US ARMY
TEST & EVALUATION COMMAND

FINAL
REPORT OF
PRODUCT IMPROVEMENT TEST OF U-8F
(ECP-BEA-L23-138)
USATECOM PROJECT NO. 4-4-1004-01

22 DEC 1964

U S ARMY
AVIATION TEST BOARD
FORT RUCKER, ALABAMA

Figure 3. Black lines denote heated area of windshield and the cleared area denotes wiper coverage.

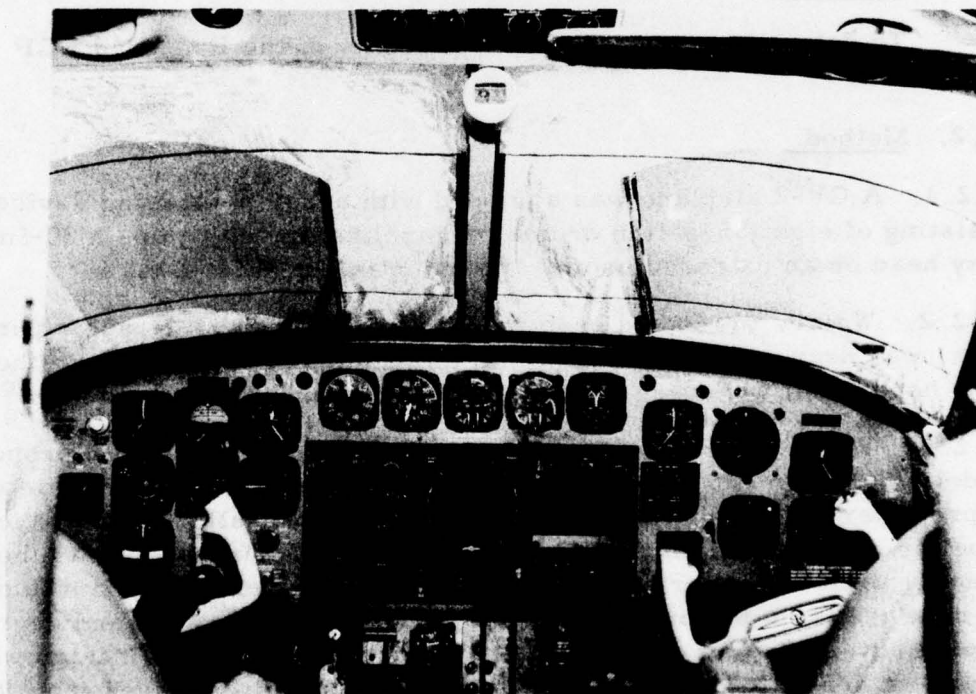
2.2.3.2.2. Heated portion of windshield did not correspond to the area cleared by the windshield wiper (figure 3).

2.2.3.2.3. The windshield wiper blades froze to the unheated portion of the windshield. Ice formation on the unheated portion of the windshield raised the wiper blades and prevented contact between the blades and windshield. Actuation of the windshield wipers while the blades were frozen to the windshield displaced the blades 90 degrees and prevented them from wiping the windshield.

3. Heated portion of windshield did not correspond to area cleared by windshield wiper.	Expand heated portion of windshield to cover area cleared by windshield wiper.	None.

Figure 4. Damaged deicer boots

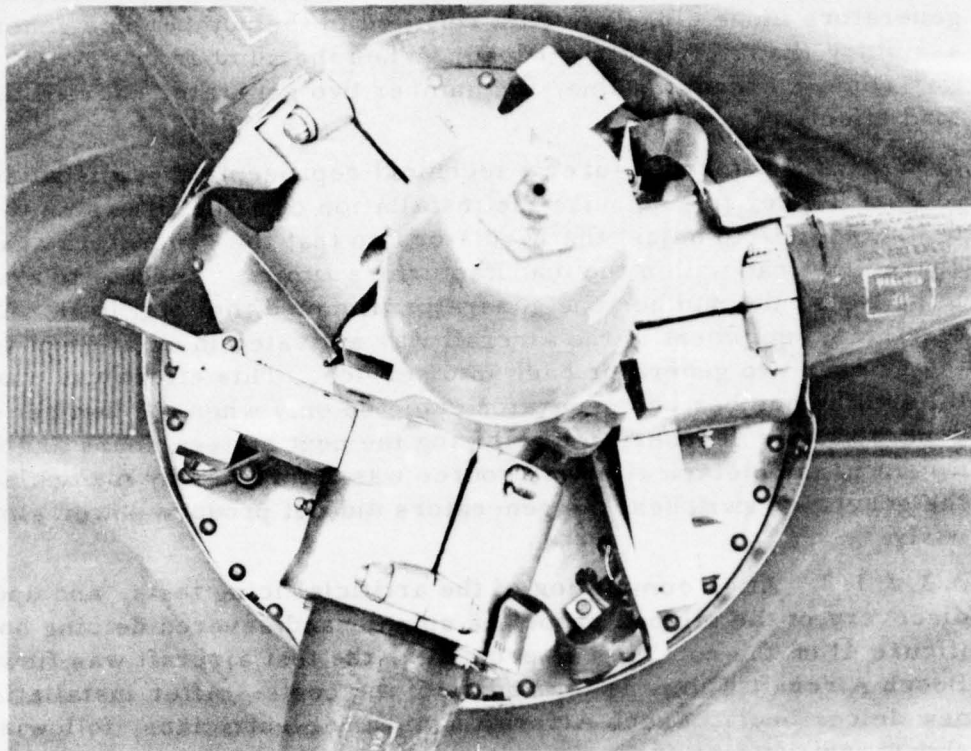
2.2.3.2. Upon the arrival of the test aircraft at Fort Rucker, the manufacturer's technical representative replaced the number one generator voltage regulator. The replaced regulator had a broken transformer mount and a broken wire in the regulator circuit (figure 5). After replacement of the voltage regulator, the number one generator still would not produce current. The new voltage regulator was later found to be defective. Both generators (and regulators) were then removed from the aircraft and returned to the manufacturer for test, repair, and calibration.

5. Propeller spinner slipped and severed propeller deicing boots.	The propeller boots be modified to prevent damage in the event of propeller spinner slippage.	None.

Figure 5. Voltage regulator showing transformer mount failure.

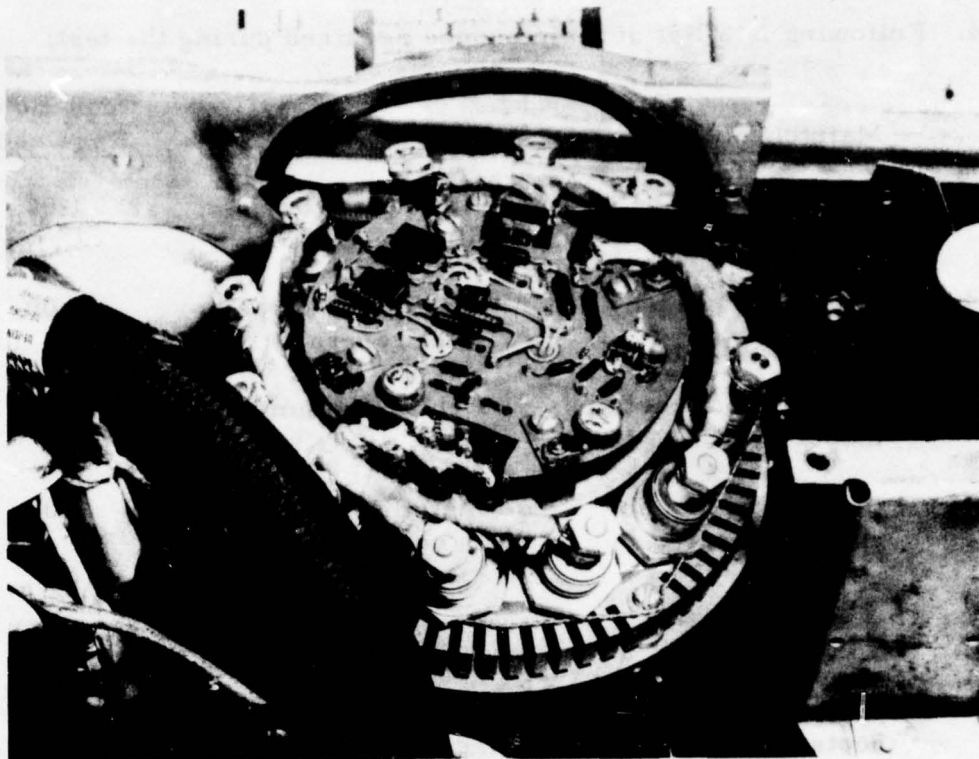
2.1.3.7. Loading sharing was a problem for the first 44 hours of the service test; three attempts were made to provide closer paralleling. These attempts were unsuccessful. After failure of No. 1 generator, the manufacturer reworked the generators and regulators, and paralleling was acceptable for the last 63 hours of test.

2.1.4.1. Modifications were made to the voltage regulators to preclude reoccurrence of failures experienced during the first 44 hours of service test. After modifications, repair, and recalibration of generators and regulators, no maintenance was required during the remaining 63 hours of testing.
